Planning Commission Agenda

Site Plan Review

Site: 27300 Southfield Road
Applicant: Abro Property Group
Plan Date: September 18, 2023
Zoning: MX Mixed Use District
Parcel ID: 24-13-353-001
Proposal: Interior / Exterior Commercial Building Renovation

PROPOSED EXTERIOR AND INTERIOR RENOVATIONS
27300 SOUTHFIELD ROAD, LATHRUP VILLAGE, MI 48706
SITE AREA: 26,800 SQ. FT. (100' x 268') OR .615 AC

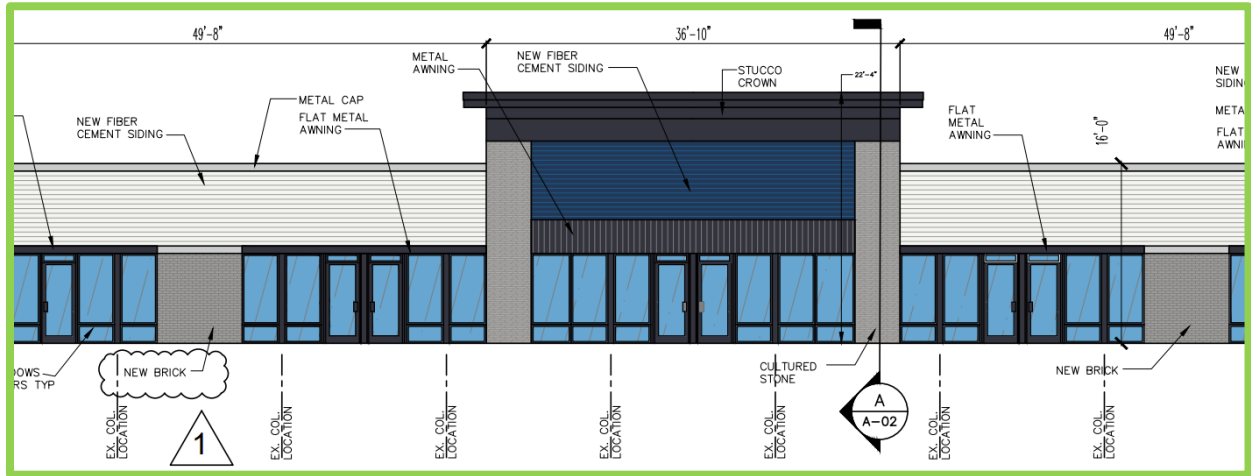
*The updated site plan shows the location of waste receptacles for each tenant space along the back alley and abutting the building. **If angled parking spaces are proposed along the rear (east) side of the building, the site plan shall demonstrate the waste receptacles have adequate space for storage and maneuverability.** No commercial dumpster is proposed at this time.*

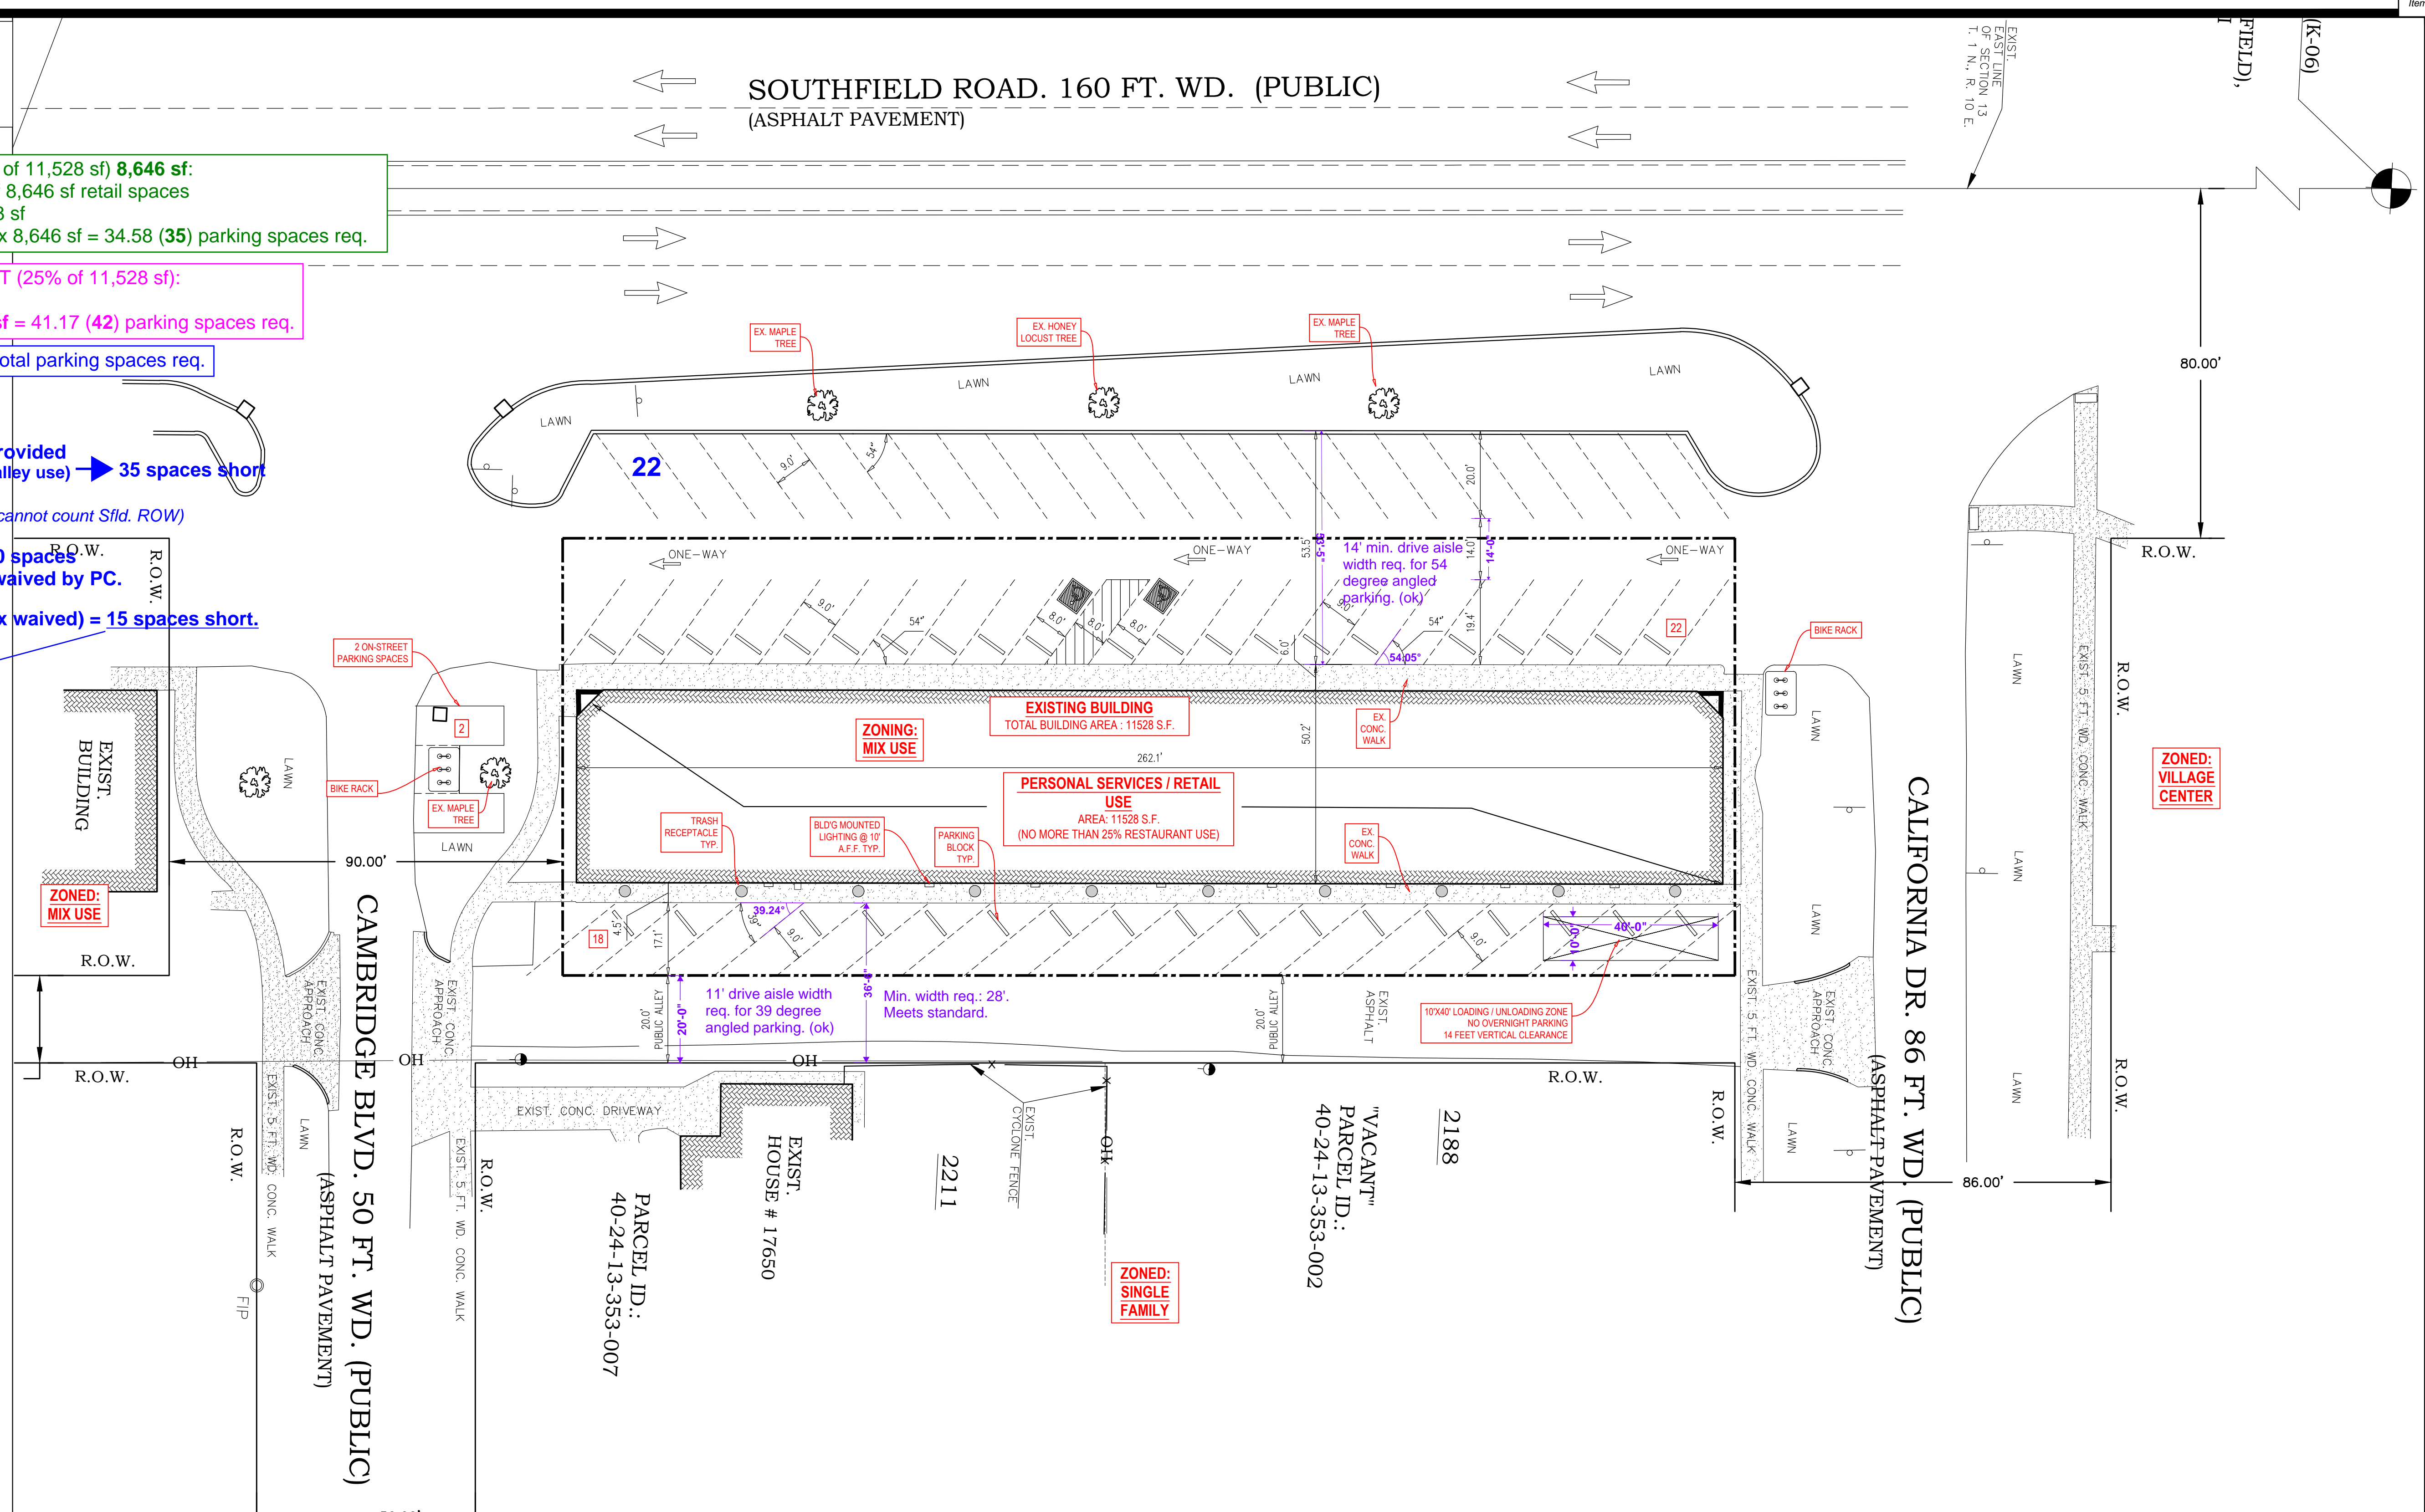
TOTAL REQUIRED SPACES AFTER PLANNING COMMISSION APPROVAL = 35 SPACES **15 spaces**

35 + 42 = 77 total parking spaces req.

= 42 spaces provided
 (agreement for alley use) → **35 spaces short**

= 22 adjacent (cannot count Sfld. ROW)

: 25% x 77 = 20 spaces
 (max) may be waived by PC.

: 35 - 20 (if max waived) = 15 spaces short.

22 spaces in Southfield ROW. May help support a variance request.

Assuming UFA is 80% of 11,528: **9,222.4 sf**
 1sp. / 200 sf UFA
 .005 x 9,222.4 sf = **47 spaces required.**

40 space provided on-site (assuming alley agreement).
2 spaces provided in ROW.
5 spaces short (may be waived by PC) -up to 22 spaces may be waived

***22 parking spaces are located in the Southfield Rd. ROW.**

ARCHITECTURAL SITE PLAN

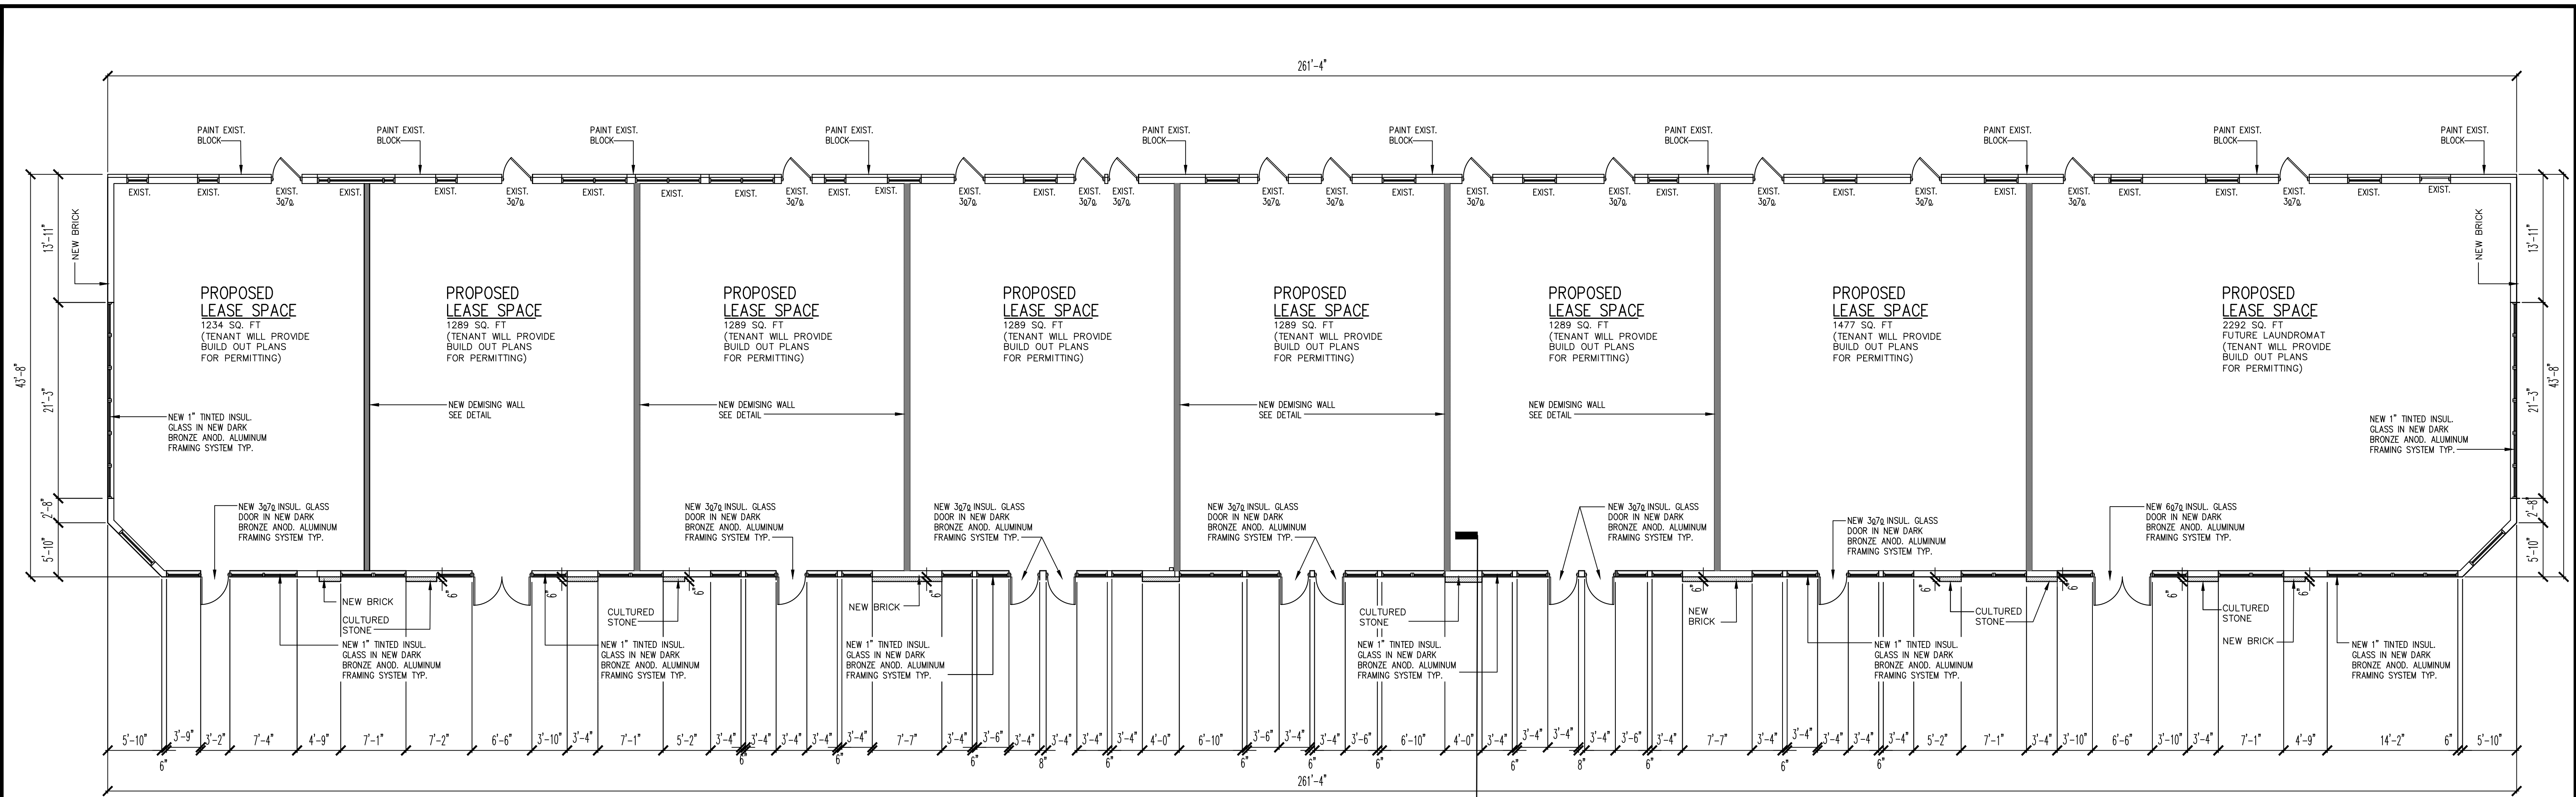
- b) The total amount of parking required for the entire site is **77 spaces** (42 + 35).
- c) With 77 parking spaces required and 40 on-site spaces provided (22 in the front and 18 in the rear), **the site**, as shown on the site plan, **is short 37 spaces or 48%**.

- d) The site plan proposes two additional parking spaces to be built in the Cambridge Boulevard right-of-way, subject to approval by the City. We note the 18 parking spaces accessed by the public alley adjacent to the rear (east) property line must maintain an agreement with the City to access all 18 on-site parking spaces. 77 spaces required, 42 spaces provided = **35 spaces short** (5.13.10.B.).

- f) We note the existing front parking area includes an additional 22 parking spaces; **however, these spaces are located entirely within the Southfield Road right-of-way and may not be counted towards the provided parking for the proposed development.**

*A 10' x 40' loading zone is located along the northeast corner of the site and obstructs 3 of the 18 angled parking spaces along the alley. As a result, 59 of the 77 parking spaces would be provided and **the site would be short 18 spaces or 23%.***

h) **The site is short 18 parking spaces. The applicant shall either find the remaining parking spaces or submit a request for variance for a reduction in the off-street parking requirements of the ordinance.**

The 18 parking spaces along the east alley and 22 parking spaces along the front of the building are shown to be in compliance with the standards of this section.

*The site is existing and there is no contiguous wall or landscaping to screen the east property line and alley from the adjacent single-family residential properties to the east. **The applicant should be prepared to discuss plans for additional screening.***

FRONT WEST ELEVATION
SCALE 1/8" = 1'-0"

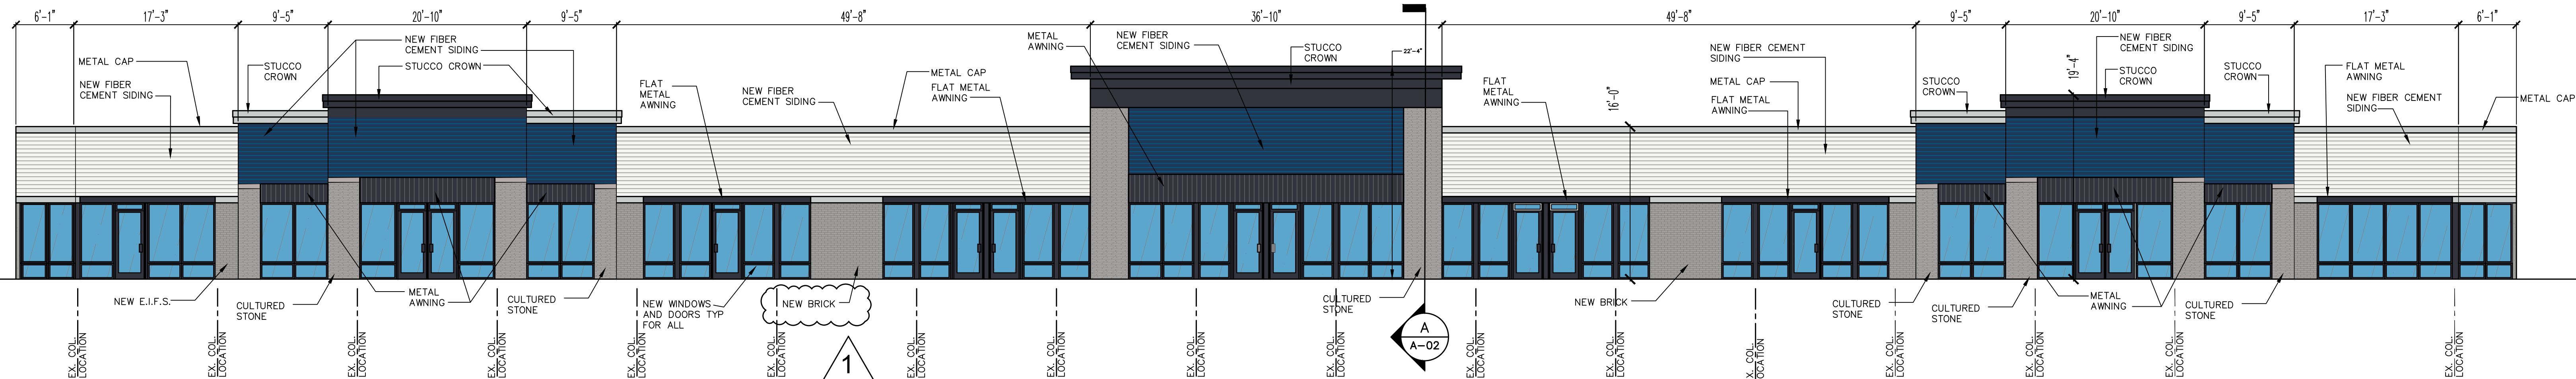
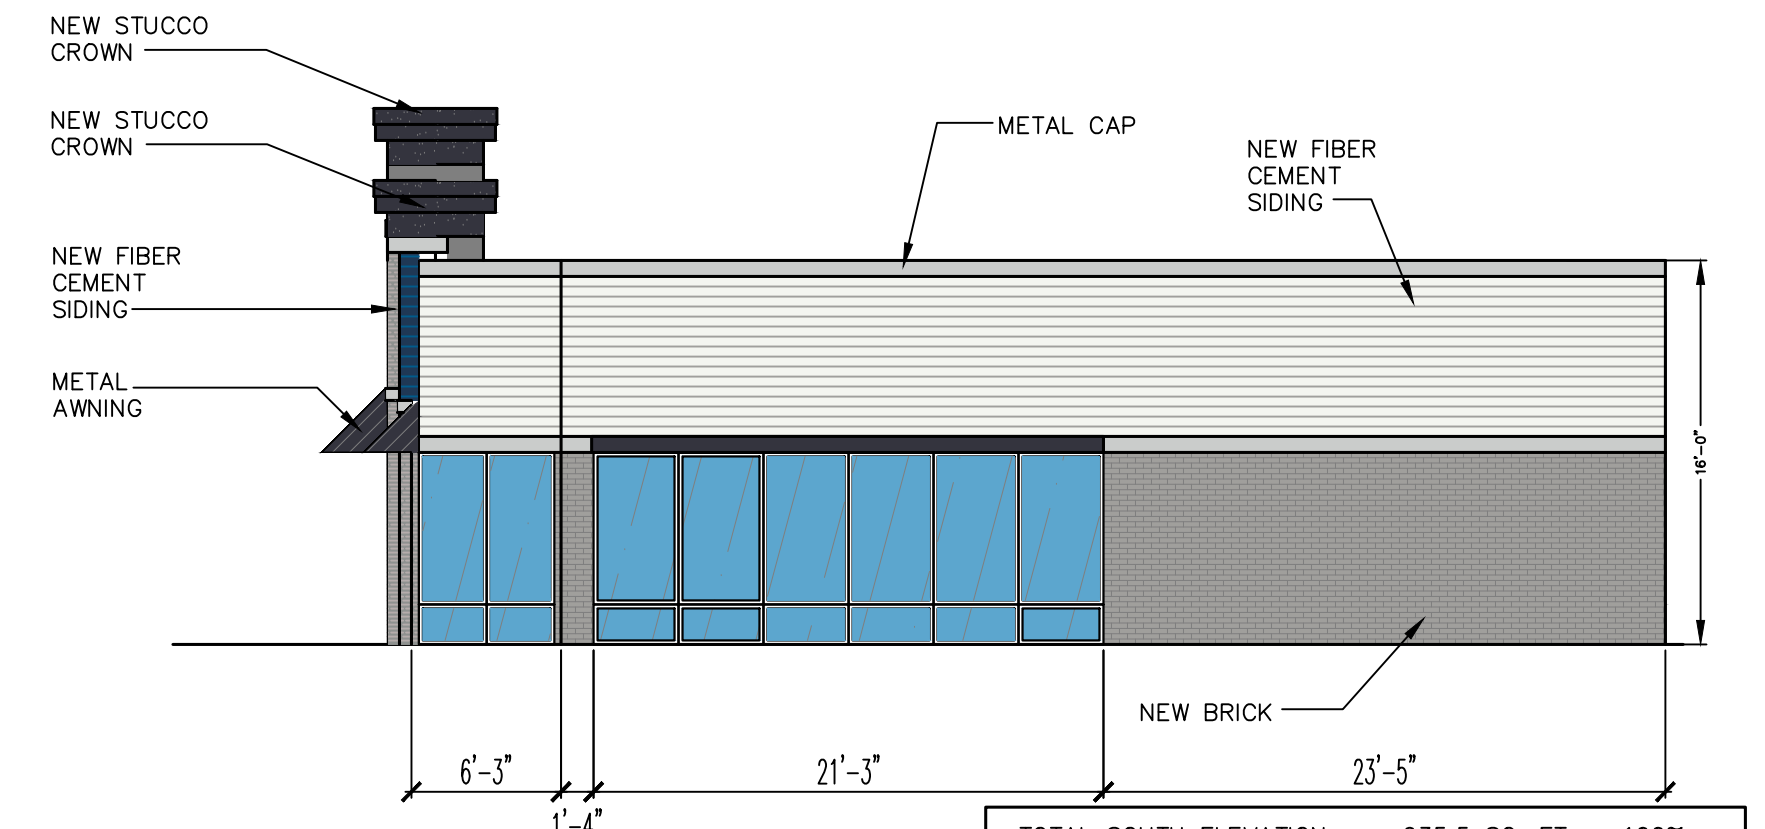
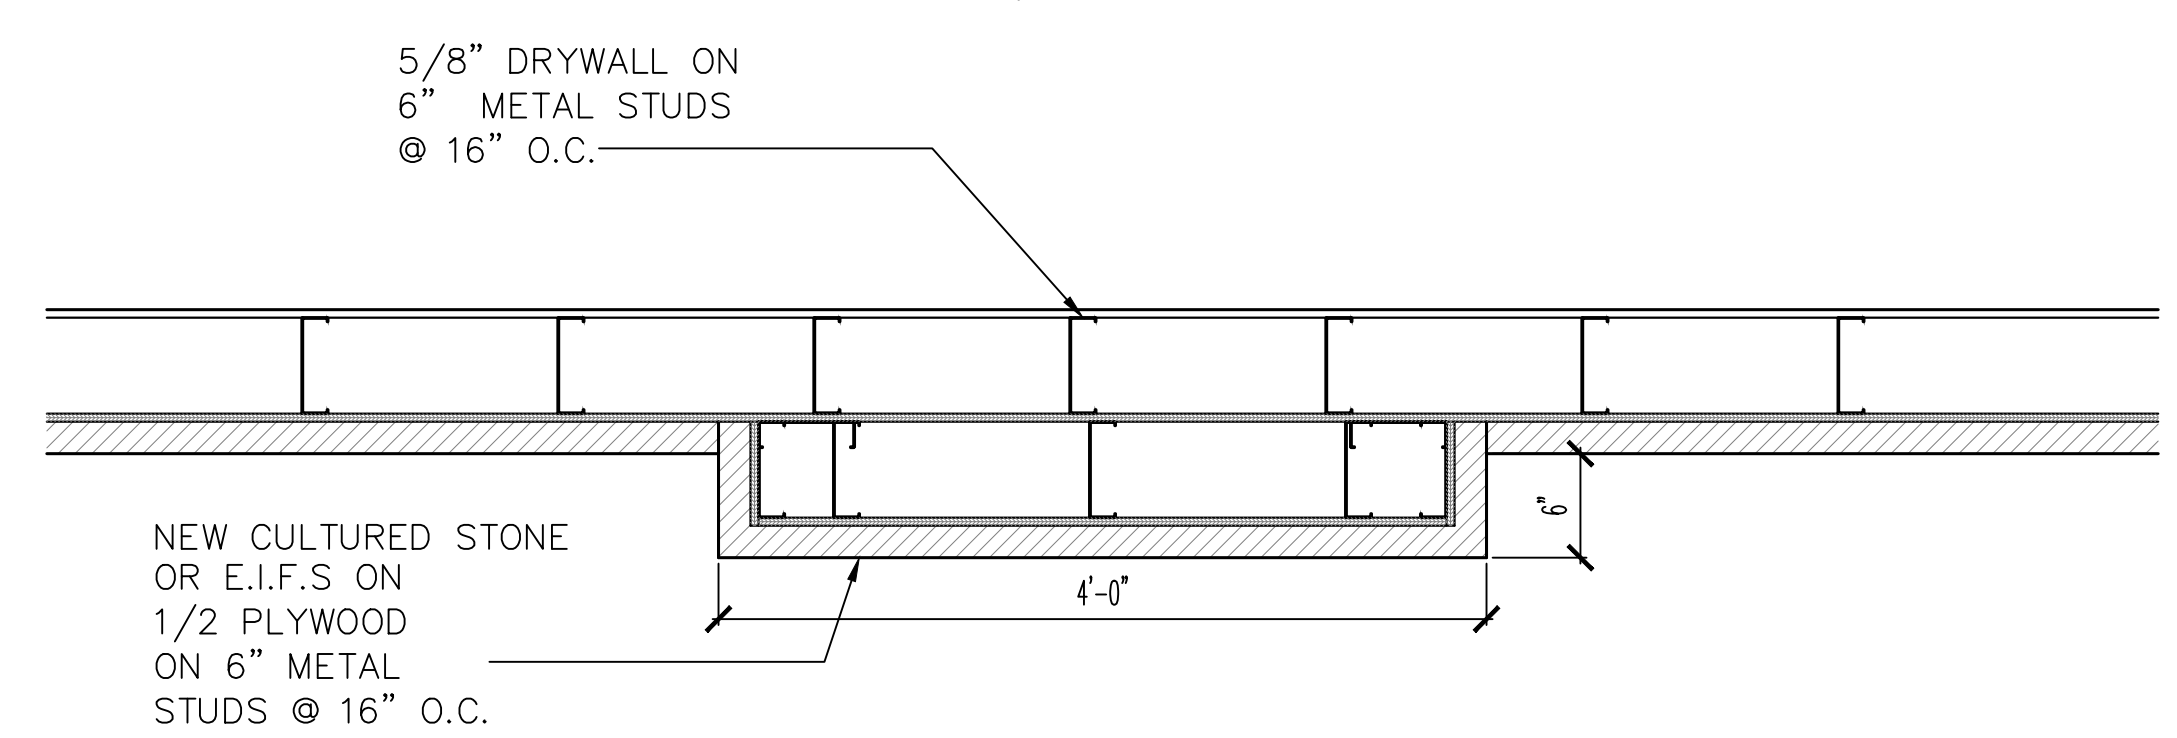
*The updated elevations show changes to the building materials. Fiber cement siding is used among much of the façade that is not accented by brick or cultured stone. Fiber cement is a masonry product designed to replace traditional wood and vinyl elements, but due to the higher sustainability, it is often used in combination with or in place of traditional brick and stone. **The applicant may consider providing samples of the proposed materials for the Planning Commission to discuss with the applicant.***

The Planning Commission may wish to discuss the appropriateness of the trim materials, particularly the stucco crowns in some areas.
